RFT 26-056 School Addition and Child Care Renovations at Milton District High School

The following, issued by the Halton District School Board (HDSB) May 14, 2026, shall be incorporated in the specifications and shall form part of the proposal document for the above.

C
SECTION THROUGH MOBILE CART

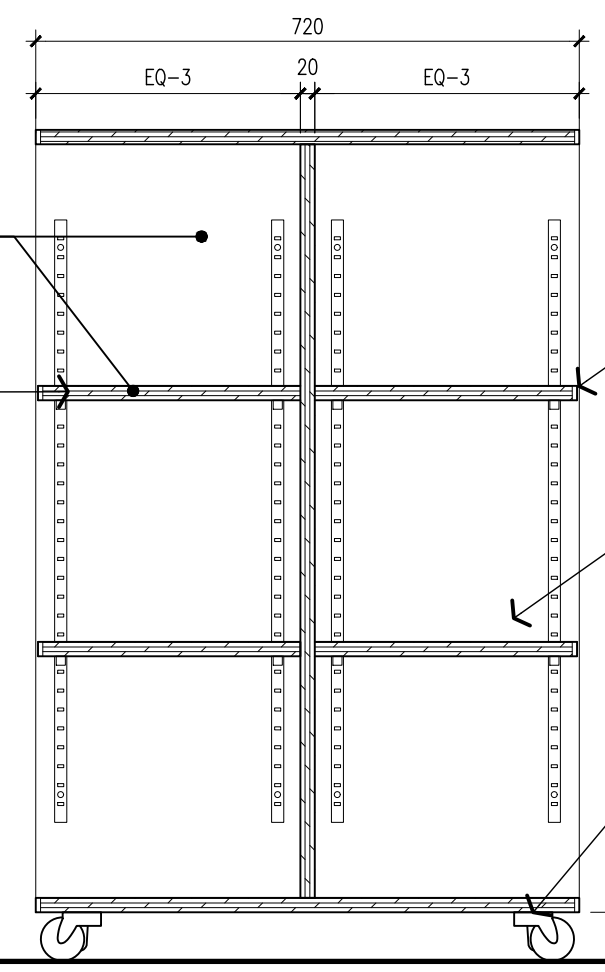
- 7.1 Teaching Cart shown in Classroom 328 as furniture supplied and installed by Owner is to be included in the Millwork package supplied and installed by this General Contractor.
- 7.2 Refer to Drawing ADD-04 SKA-01 for details. Construction to be plywood with plastic laminate finish. Dwg. contained here-in. Note supply 2 per Classroom.

NOTE:
THERE ARE TO BE 2 MOBILE CARTS PROVIDED IN EACH CLASSROOM

PAVEMENT STRUCTURE

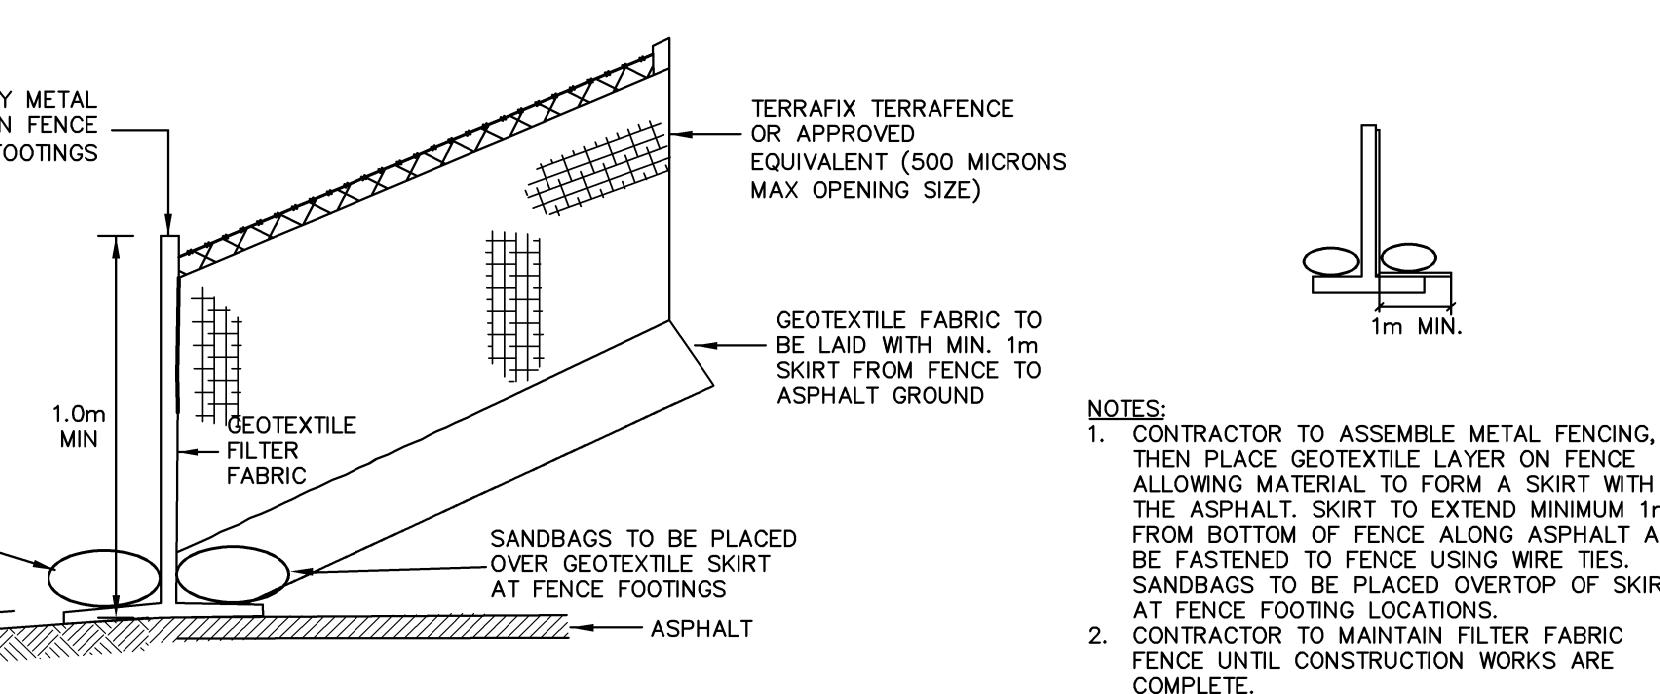
The light duty asphalt for the child play area in the landscaping drawings shows 40mm HL3 and 60mm HL8. The civil drawings show 40mm HL3 & 50mm HL8. Please clarify which is to be followed.

We recommend that the MTE detail for light duty asphalt be followed. Aboud has deleted the light duty asphalt detail from the landscape set in addendum #3. MTE drawing C2.3 pavement structure table has been updated. Light duty asphalt structure shown on civil plans to be used for passenger car parking.
